Access Compliance Report

Public Rights-of-Way

Intersection ID: 10033070	Main Street: NORTH_COMMUNITY_HOUSE_RD	Cross Street: N/A	Location: NW
ADA ID: B476B35B8058	Ramp Type: Perp	Initial Pass/Fail: Fail	Overall Compliance: No
Severity Score: 13.75			
Codes/Mitigation Info/Possible Solution		Field Measurements/Component Compliance

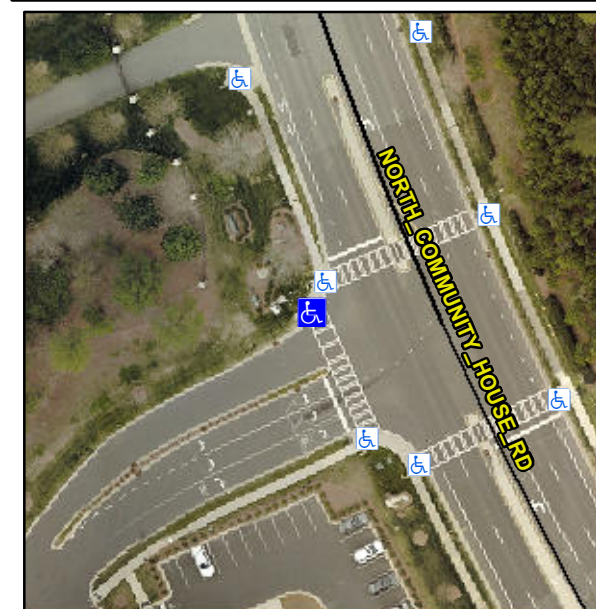
Not Found, R304.2.2

Compliance	Description	Data	Compliance	Description	Data
N/A	Ramp Length (in)	27.0	No	Ramp Slope (%)	10.3
Yes	Ramp Width (in)	48.0	Yes	Ramp XSlope (%)	4.0
N/A	Flare Type LT	N/A	N/A	Flare Type RT	N/A
N/A	Flare Slope LT (%)	N/A	N/A	Flare Slope RT (%)	N/A
N/A	Flare Traversable LT?	N/A	N/A	Flare Traversable RT?	N/A
N/A	Landing Length (in)	N/A	N/A	DWS Provided?	N/A
N/A	Landing Width (in)	N/A	N/A	DWS Contrast?	N/A
N/A	Landing Slope (%)	N/A	N/A	DWS Length (in)	N/A
N/A	Landing X Slope (%)	N/A	N/A	DWS Full Width?	N/A
N/A	Landing Curb? (Y/N)	N/A	N/A	DWS Offset (in)	N/A
N/A	Shared Landing?	N/A			
N/A	Gutter Ponding?	N/A	N/A	Gutter Slope (%)	N/A
N/A	Gutter Lip Ht (in)	N/A	N/A	Gutter X Slope (%)	N/A
N/A	Painted X Walk1?	Yes	N/A	Painted X Walk2?	N/A
	X Walk 1 Direction	To SE		X Walk 2 Direction	N/A
N/A	X Walk 1 Width (in)	113.0	N/A	X Walk 2 Width (in)	N/A
	X Walk 1 Slope (%)	1.9		X Walk 2 Slope (%)	N/A
	X Walk 1 X Slope (%)	5.8		X Walk 2 X Slope (%)	N/A

Remove & Replace Entire Ramp.
